Field Application Document (FA)

FIELD CHANGE ORDER	NUMBER: KA45-F002 KA47-F002
--------------------	--------------------------------

APPLICABILITY: This "F" coded FCO should be installed in all Microvax 3100 Model 30, 40, and 80 which contain part rev below M02 or M03 for FRU 54-20654-01 (Model 30 and Model 40) and part rev below J02 or J03 for FRU 54-20652-01 (Model 80). This FCO incorporates ECO No. 54-20654-TWO007 for Model 30 and Model 40 and ECO No.5420652-TWO006. Please do not make a separate trip just to install FCO unless customer is down. Install the FCO next time you go to the Customer site.

Figure 1 - Diagram of KA45-AA CPU Board used in MicroVAX 3100-30, -40

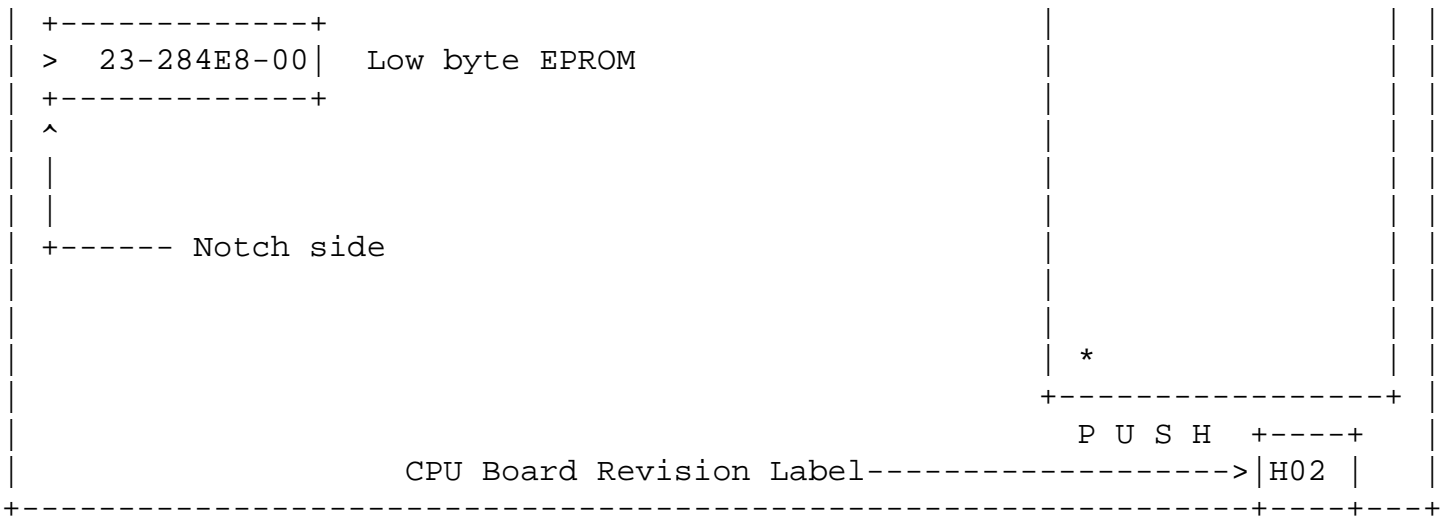
Replace ROM 23-266E8-00 or ROM 23-223E8-00 or ROM 23-149E8-00 at location E167 with new ROM 23-284E8-00 and replace ROM 23-267E8-00 or ROM 23-224E8-00 or ROM 23-150E8-00 at location E168 with new ROM 23-285E8-00.

- b. Locate the firmware EPROM with either part number 23-150E8-00, 23-224E8-00, or 23-267E8-00 (High Byte). Use an IC remover or small screw driver to remove the EPROM from the socket. Replace with EPROM 23-285E8-00 supplied in the kit. Observe the orientation of the notch in the ROM package.

c. Locate the firmware EPROM with either part number 23-149E8-00, 23-223E8-00, or 23-266E8-00 (Low Byte). Use an IC remover or small screw driver to remove the EPROM from the socket. Replace with EPROM 23-284E8-00 supplied in the kit. Observe the orientation of the notch in the ROM package.

Figure 2 - Diagram of KA47-AA CPU Board used in MicroVAX 3100-80

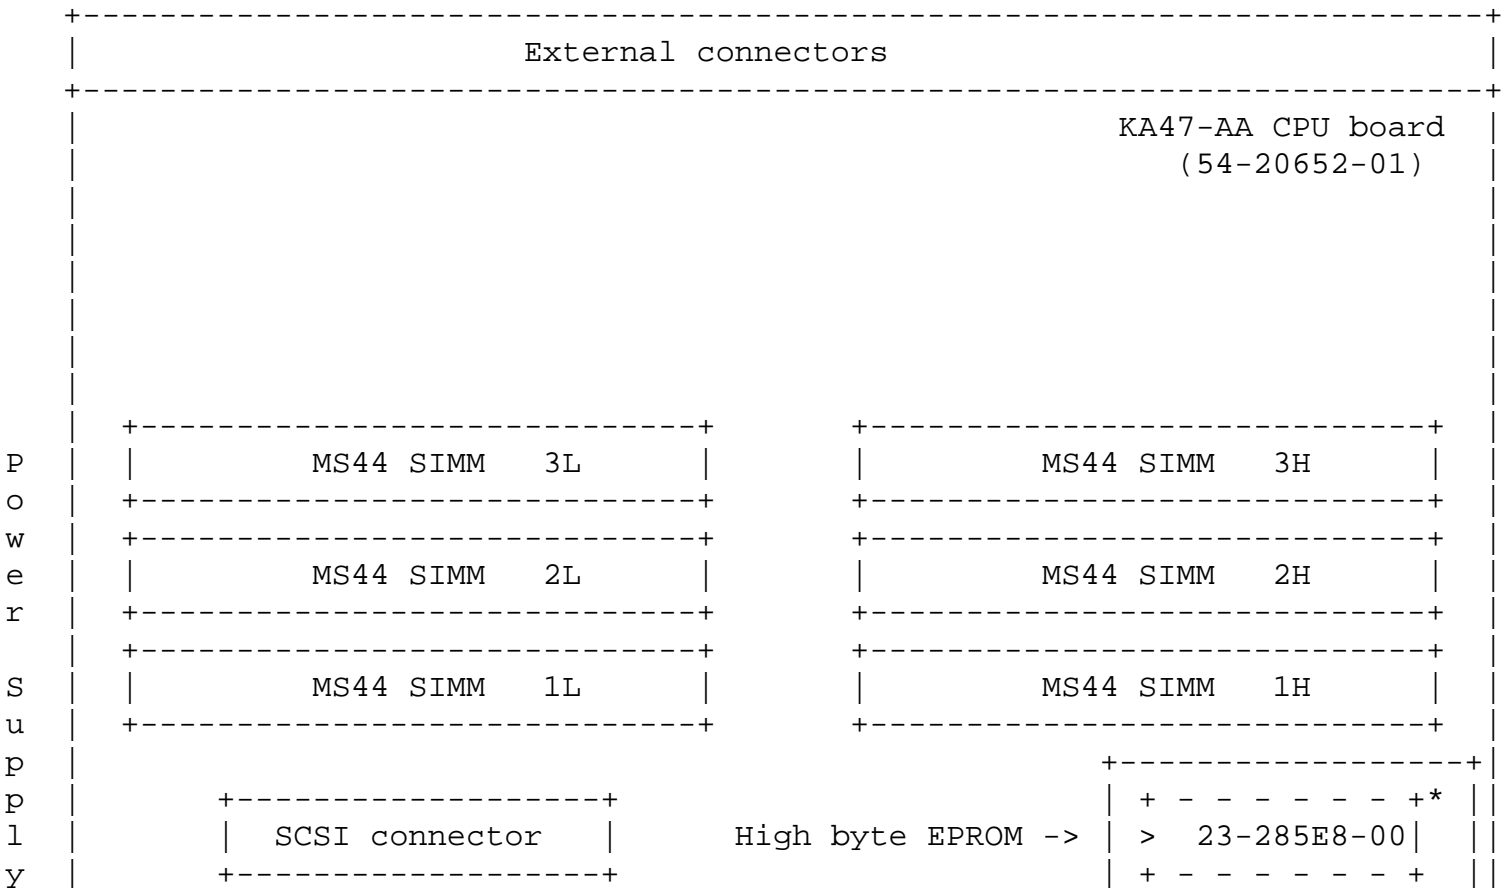
Replace ROM 23-266E8-00 or ROM 23-223E8-00 or ROM 23-149E8-00 at location E15 with new ROM 23-284E8-00 and replace ROM 23-267E8-00 or ROM 23-224E8-00 or ROM 23-150E8-00 at location E16 with new ROM 23-285E8-00.

Both EPROM's are
located under the
54-20662-01 logic board
